**Re: MUZ Project - RTF/ICSC GR Committee Comments re CE Zoning**

This letter is submitted on behalf of the Retail Task Force (RTF) and the Oregon Government Relations Committee for the International Council of Shopping Centers (ICSC) regarding the proposed Mixed Use Zones Project. Please make this letter a part of your hearing record.

# CE ZONE & NON-CMSO RECOMMENDATIONS Portland, Oregon

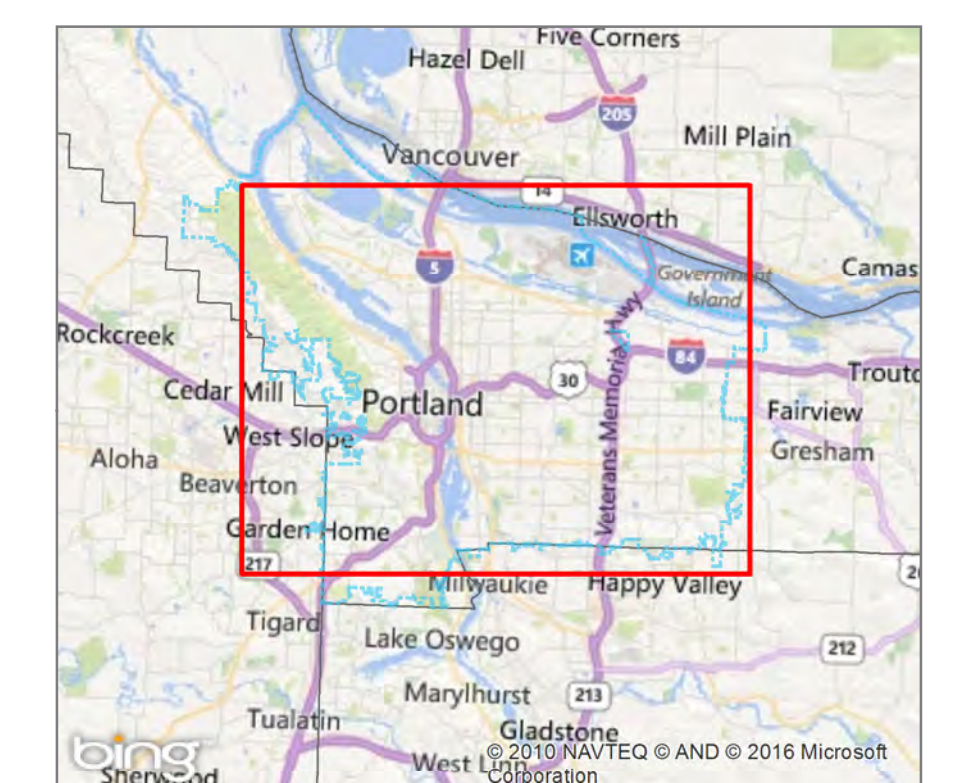
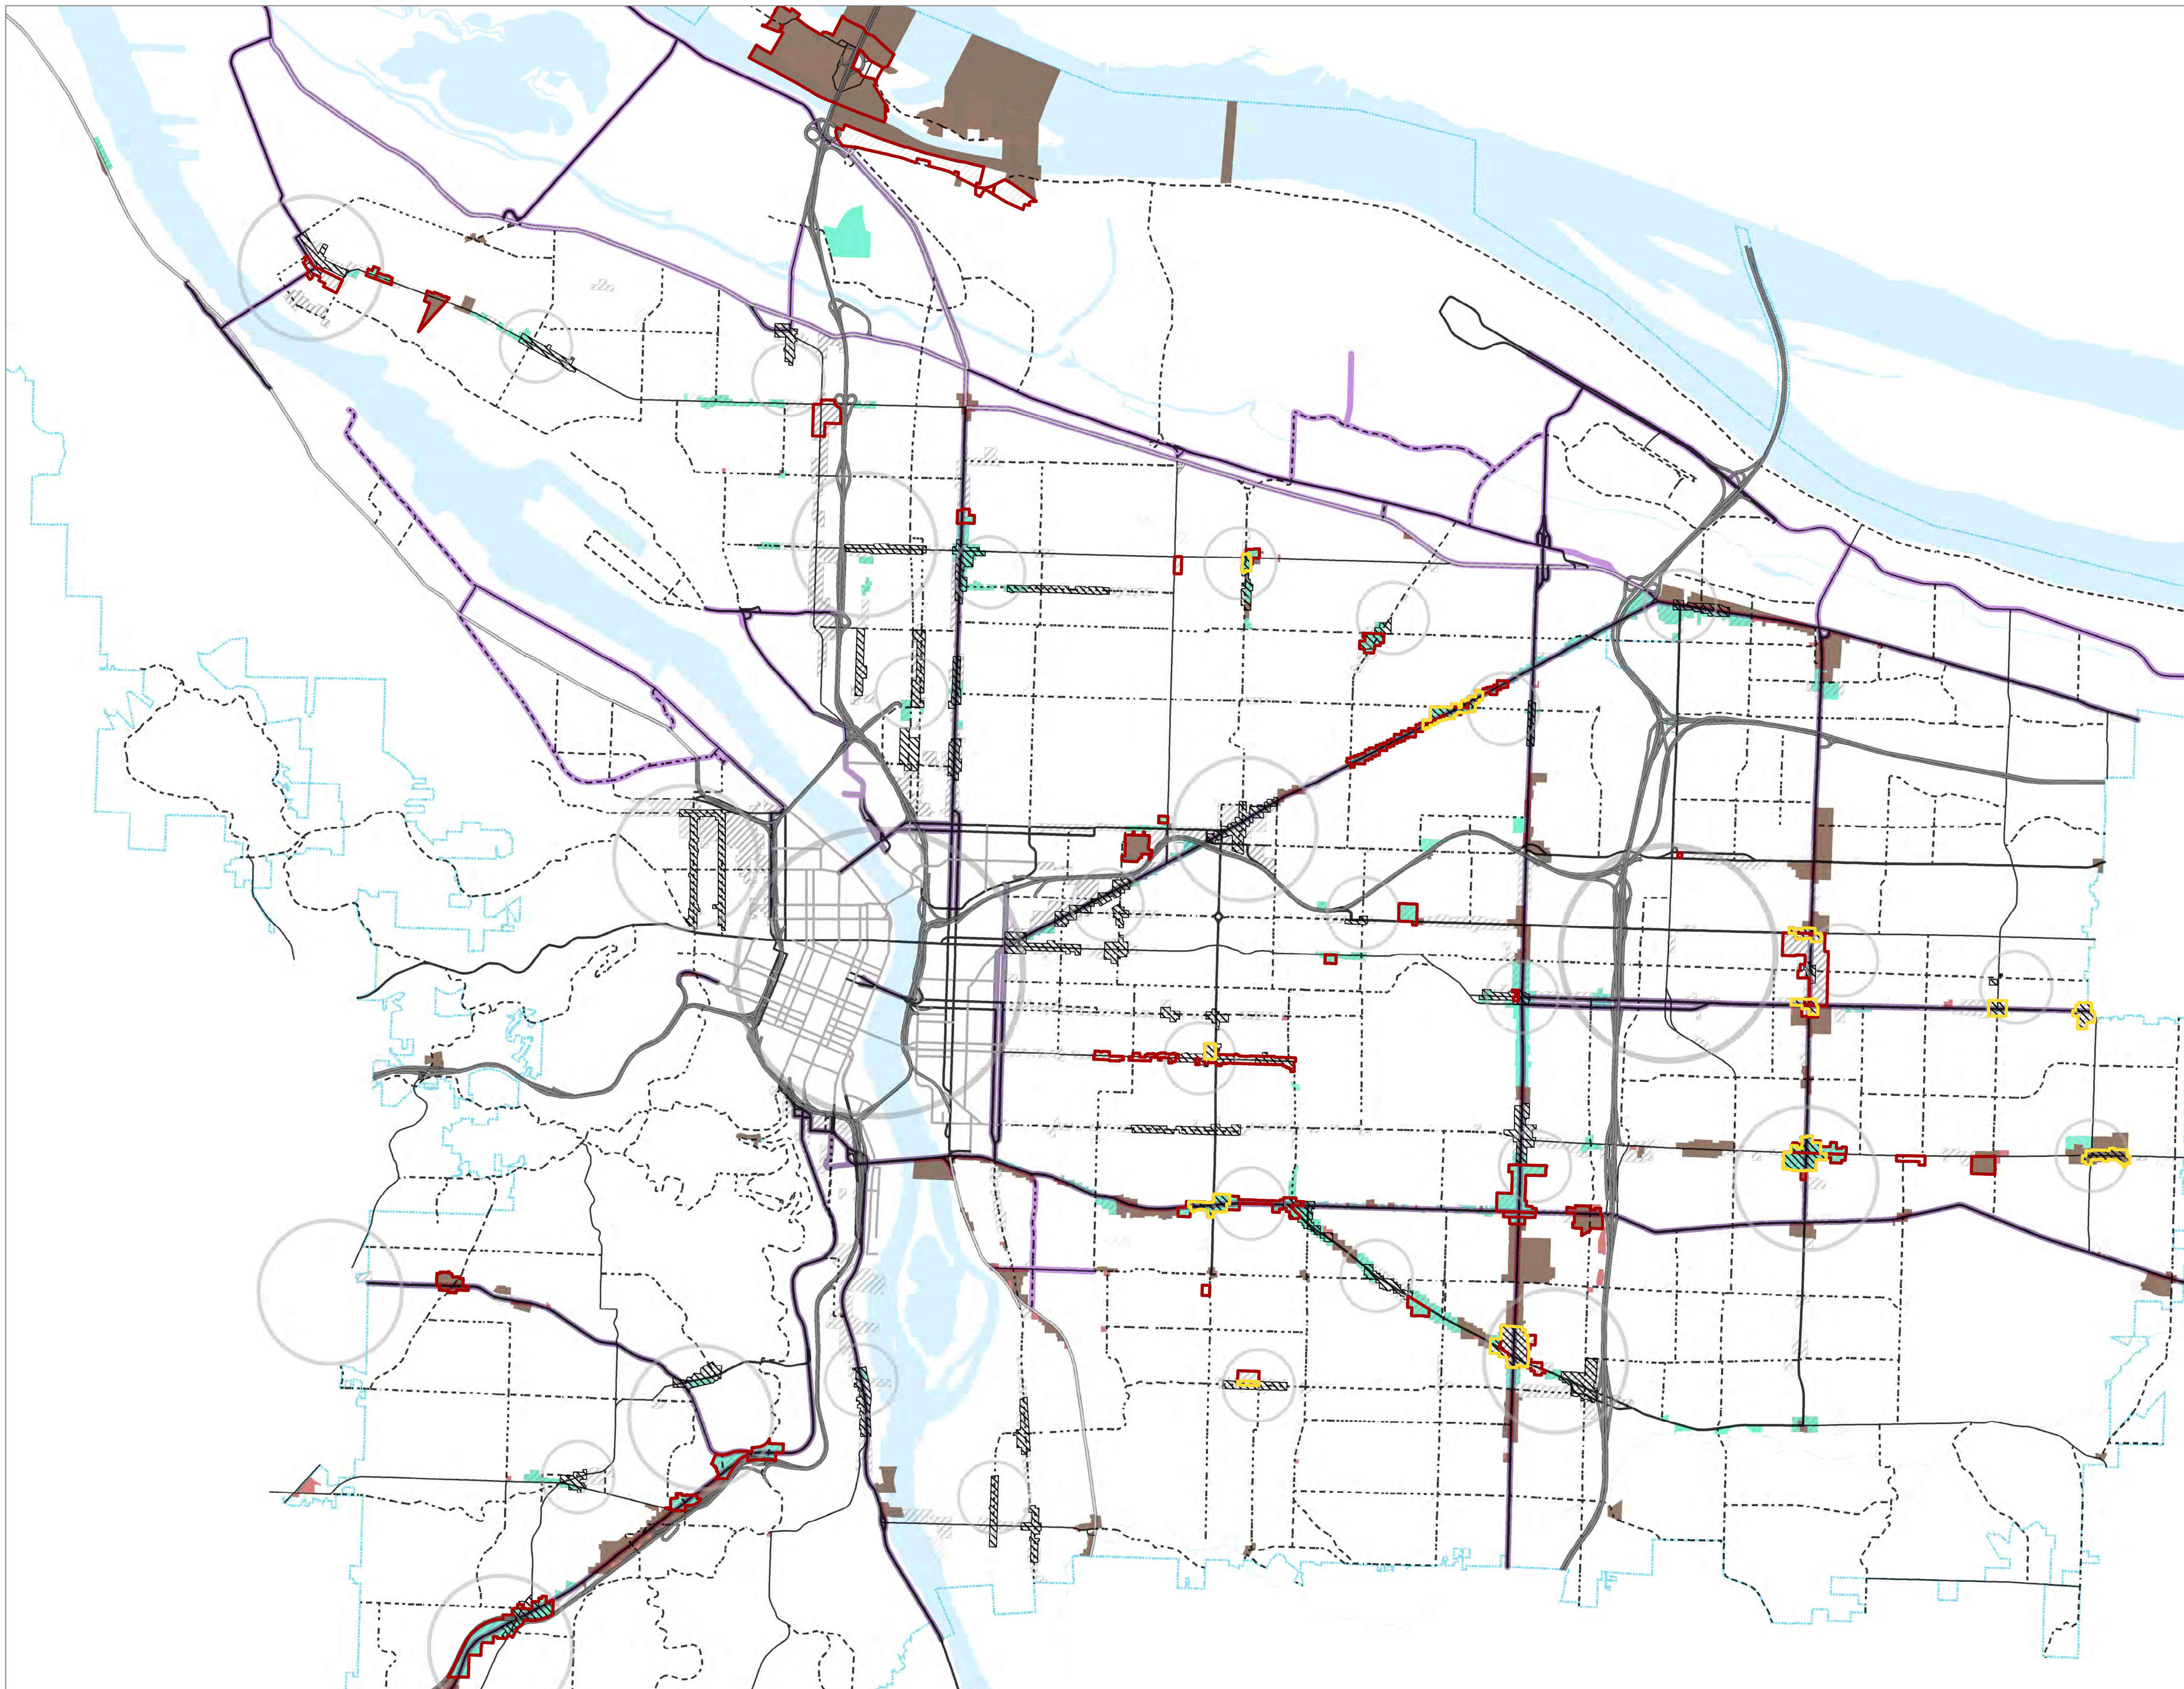
The City should increase the amount of CE zoning where the property fits the locational criteria of the CE zone regarding existing auto-accommodating development, rather than decreasing it, for the above reasons. The City should do a bottom-up rather than a top-down zoning exercise, since the City is a built environment and not a blank planning slate. We have prepared and attached a proposed CE map to show existing commercial lands that need to be zoned CE in satisfaction of the locational standard of the CE zone paraphrased as: built as auto-oriented in an area not likely to urbanize soon.<sup>2</sup> It also appears that the areas for the new Comprehensive Plan designations allowing the CE zone as a corresponding zone should also be increased, an issue that we raised in our testimony to City Council, as well as our position that the City's Goal 9

**Figure VII-1: Commercial/Mixed Use Rezoning Summary**

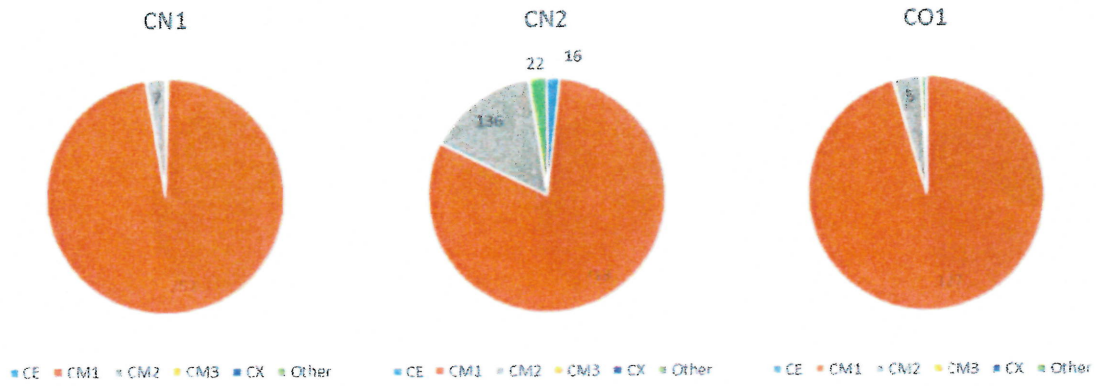
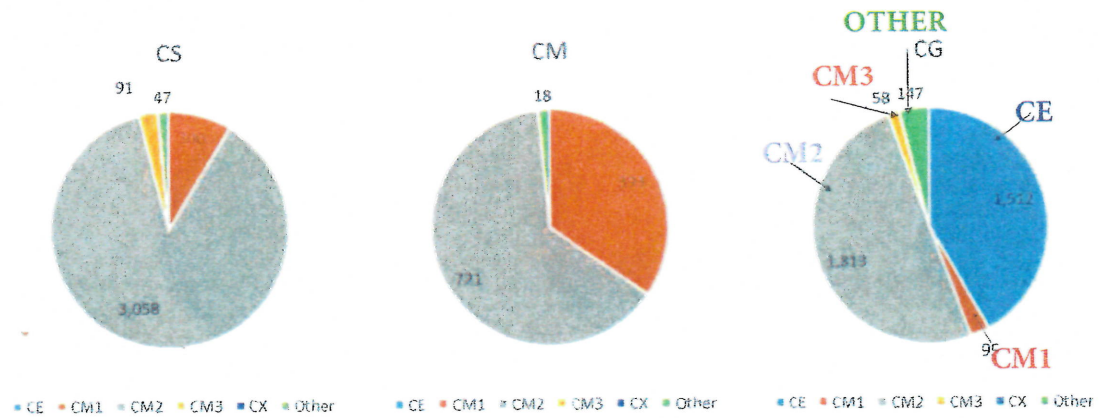
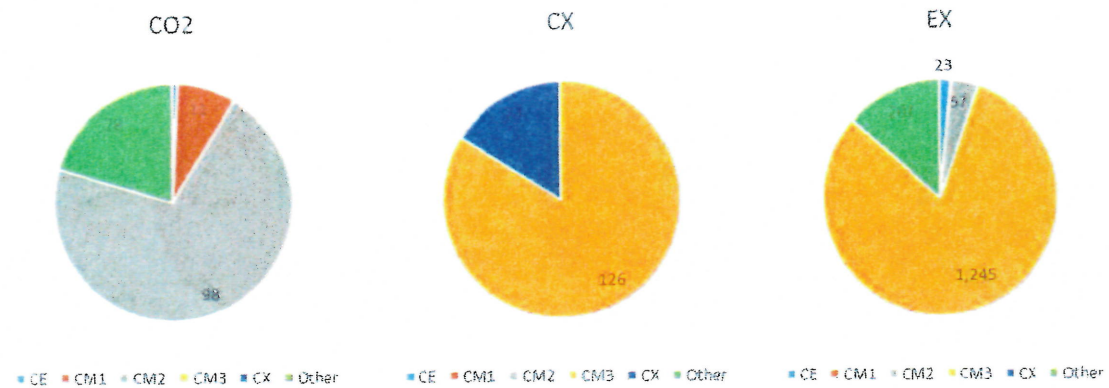
The only zone remotely suitable for that type of development under the Mixed Use Zones Project is the new CE zone, most similar to the old CG zone, both of which are auto-accommodating. However, the purpose statement for the new CE zone is for a mixed-use first, with auto-accommodation only a second thought. Accordingly, the MUZ project offers no purely auto-accommodating zone. We believe that the City should proceed in a two-step fashion to address that omission: 1) zone land CE that is now zoned CG or developed for auto-accommodation; and 2) make the CE zone more auto-accommodating. Unfortunately, approximately 40% of the land currently zoned CG and approximately 60% of the properties now zoned CG are being converted to zones other than the CE zone, thus dramatically reducing the City's inventory of auto-accommodating land zoned for grocery supermarket and other auto-accommodating development. See Figure VII-1 and Figure VII-2 attached.
